APPENDIX E.8
REGULATORY CORRESPONDENCE

CIRNAC INSPECTION REPORTS AND BAFFINLAND RESPONSES

WATER LICENCE INSPECTION FORM

RE: Water Licence 2AM-MRY1325 August 2018 Inspection Report

Figure 4: East side of Waste Rock Stockpile.

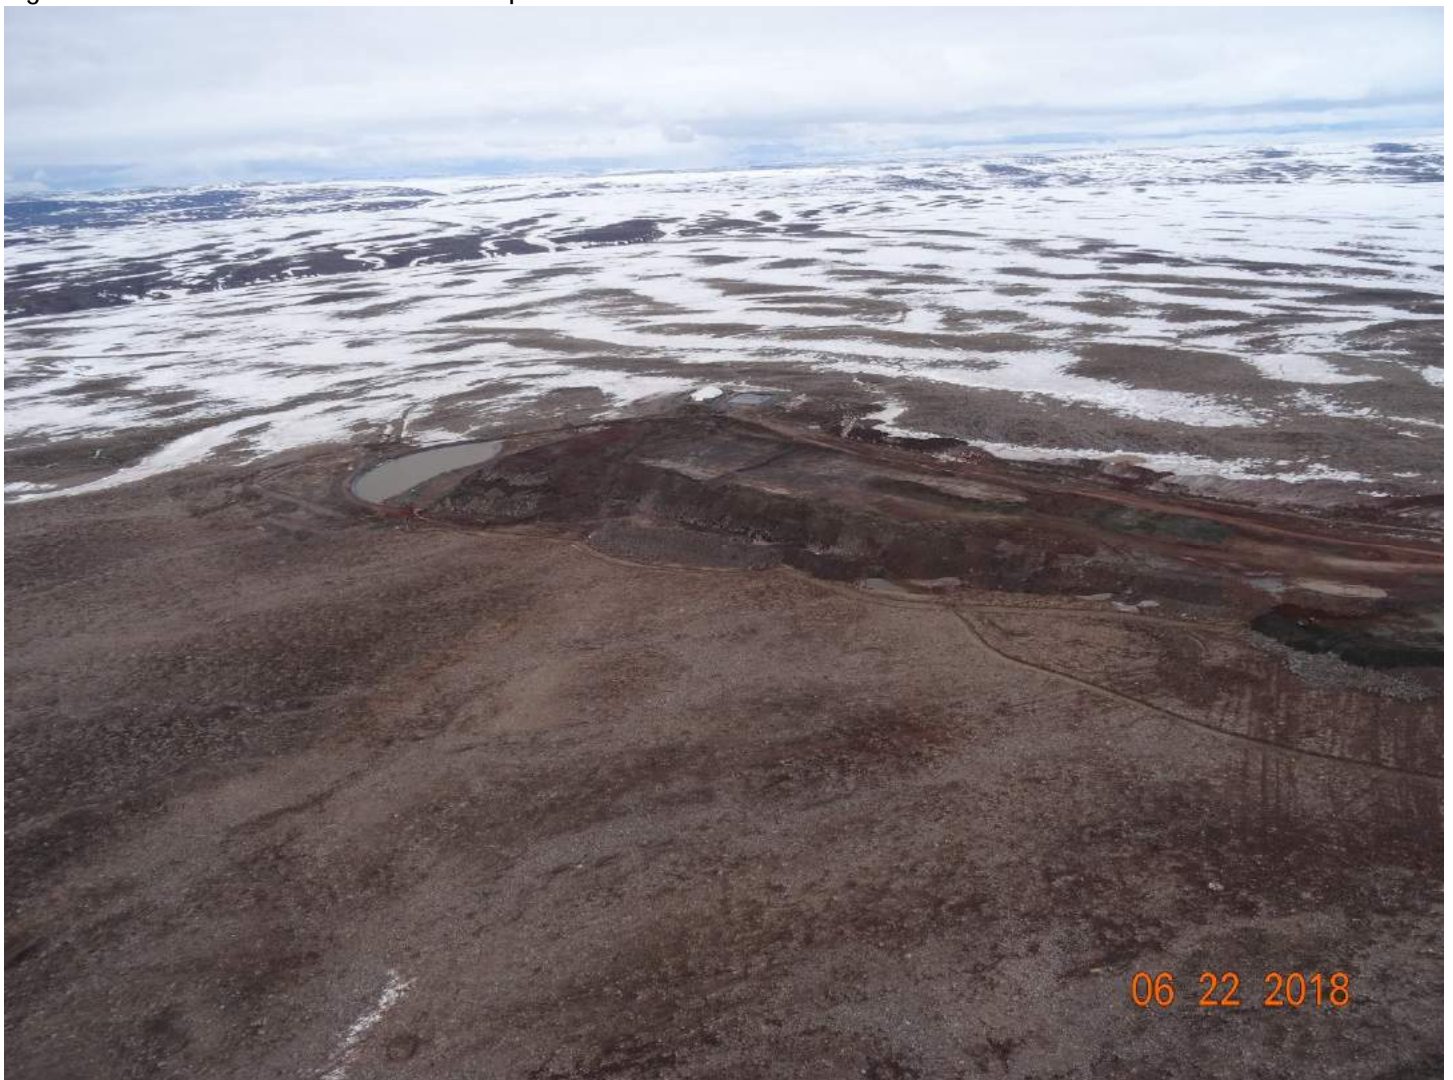
- c. See figures 4 and 5 for photos of the Waste Rock Stockpile.

Photo 3

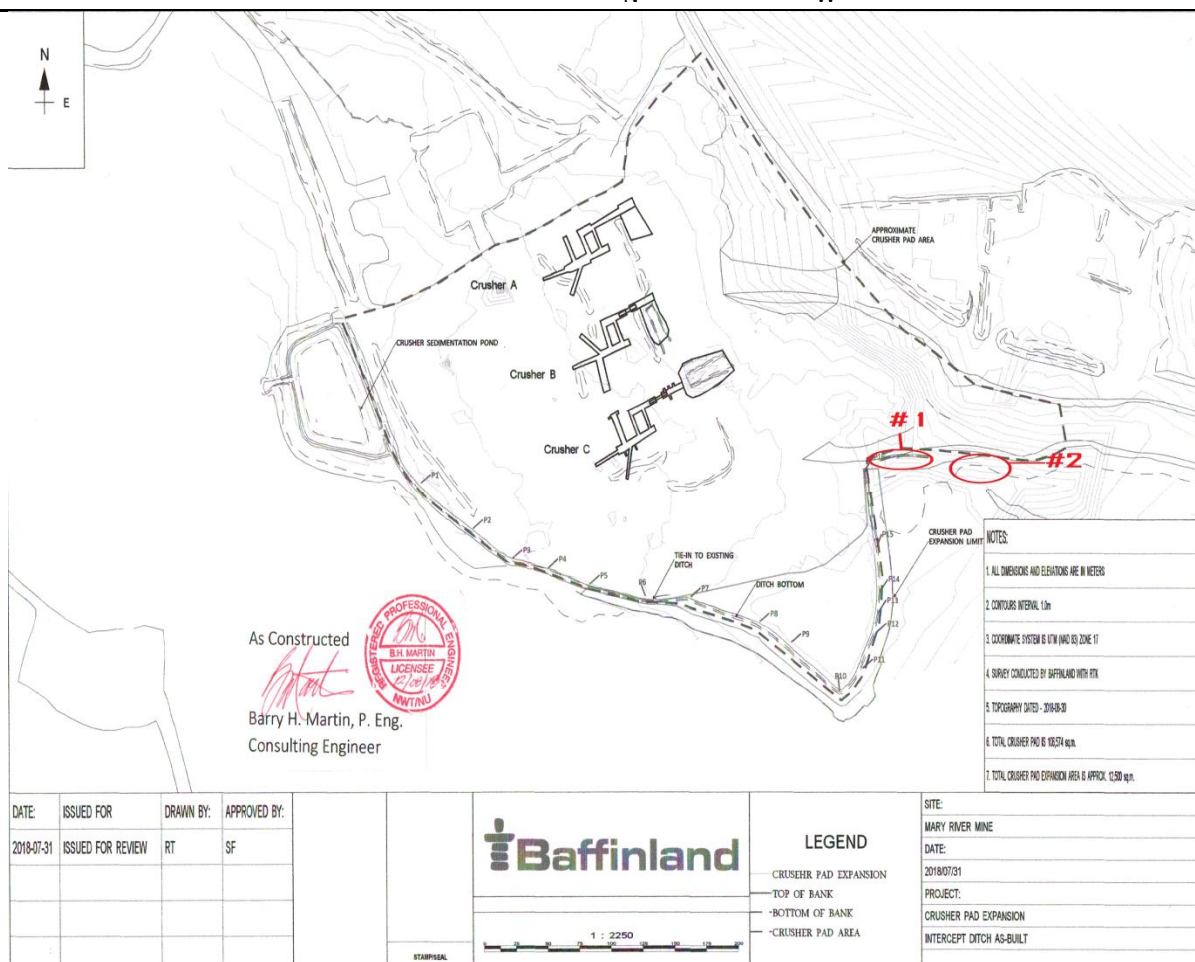
c. During the inspection it was noted that, a pile of iron ore is outside of containment. Please remove the ore from outside containment, see Photo 3. A red circle labeled "#2" identifies the misplaced iron ore's location.

- I. "All drainage ditches should be of trapezoidal cross sections, where possible." This does not appear to be applied at the location identified in photo #3. A red circle labeled "#1" identifies this location.

ITEM No.¹	Action Required with Observation or Item of Concern	Baffinland Responses
Section 1		
1.c.	During the inspection it was noted that, a pile of iron ore is outside of containment. Photo 3; A red circle labeled “#2” identifies the misplaced iron ore’s location.	Baffinland will remove this ore outside of the South-East ditching during October, 2018.

Photo 12

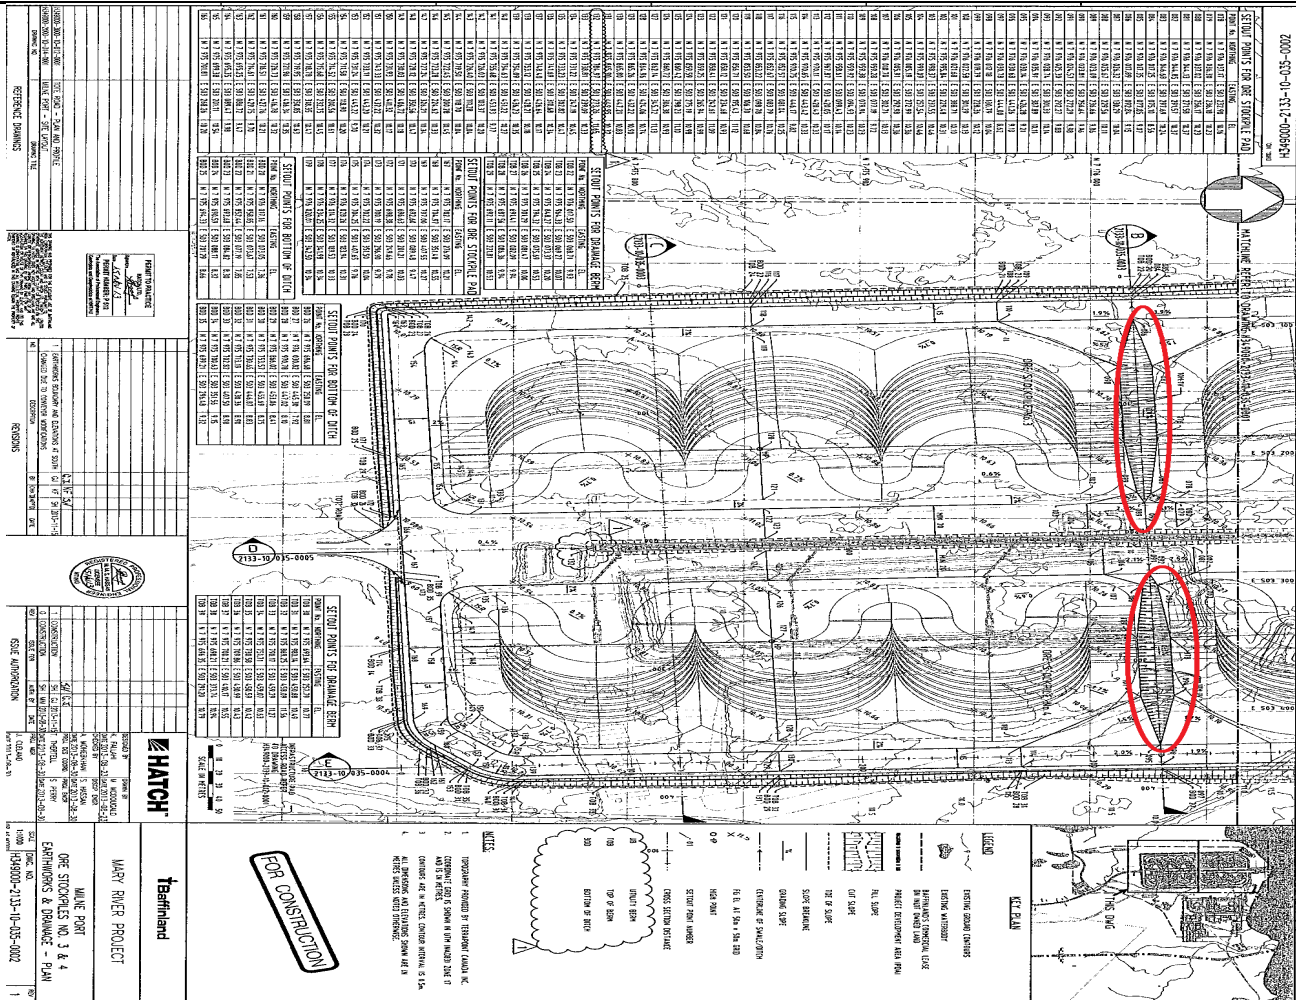
- a. During the inspection it was noted that the swales highlighted in photo #12 have not been installed/implemented.
- b. There was ore outside containment on the South-West corner of the facility; the licensee is to recover this Ore from outside containment.
- c. The ditch on the East side of the conveyer belt appears to be sloping away from the sedimentation pond.
- d. Remnants of the original bulk sample are still left outside of containment to the east of the west sedimentation pond; Baffinland is to remove the remainder of the bulk sample.

Description; Swales circled in red do not appear implemented.

4. Once the Ore stockpile pad is clear of Ore, the licensee is to clear the swales highlighted in photo #12 and keep them clear of Iron Ore so that the pad operates as intended.
5. The licensee is to ensure that the slope of the ditches surrounding the Ore Stockpile Pad corresponds with the approved design.
6. The licensee is to return the Western Global Fuel module at Milne Inlet to its original approved design.
7. The licensee is to correspond with the NWB and follow the required processes to install the required water management structures to prevent water from flooding the roads identified in Photo's 14 and 15.
